Topic: ENERGY STAR® Product Specification for Room Air Conditioners Eligibility Criteria Draft 1 Version 6.0 and Version 7.0

This letter comprises the comments of the Pacific Gas and Electric Company (PG&E), San Diego Gas and Electric (SDG&E), and Southern California Edison (SCE), collectively referred to herein as the California Investor-Owned Utilities (CA IOUs), in response to the United States (U.S.) Environmental Protection Agency (EPA) proposed version 6.0 and version 7.0 Draft 1 product eligibility criteria for Room Air Conditioners (RAC).

Figure 3. Example graphic that includes elements (a)-(d).

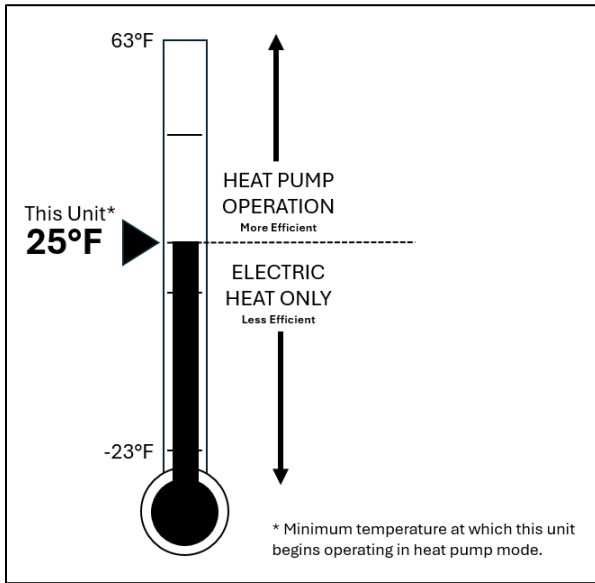
3. EPA should require a graphical label that clearly shows the most suitable climate for different room heat pumps.

The CA IOUs agree that a graphical label is helpful for consumers when making purchasing decisions. Describing RHPs merely as Type 1 through 4 will not effectively communicate each product Type's functionality to consumers who are likely unfamiliar with these terms. A graphical label may help consumers better understand equipment behavior, purchase the most appropriate RHP for their climate, and set realistic expectations about the units performance while operating as a heat pump.

A graphical symbol should include elements (a)-(d) below. These elements are intended to strike a balance between creating a functionally useful and easy to understand label without providing too much information resulting in a confusing and ineffectual symbol. Figure 3 demonstrates a label that utilizes elements (a)-(d).

- a) Text and arrows showing the temperature range over which the unit can be expected to operate in heat pump mode compared to the electric resistance heat-only mode.
- b) Text that explains when the equipment will operate more efficiently or less efficiently.
- c) A triangular symbol indicating the model's compressor cut-in temperature. The numeric value of the Compressor Cut-In temperature should be listed next to this symbol, and an explanatory text should define the meaning of compressor cut-in temperature. We suggest a statement such as, "Temperature at which this unit begins operating in heat pump mode."

- d) When such information becomes available, the image should present the minimum and maximum compressor cut-in temperatures to help consumers better understand the model's capabilities relative to other options.
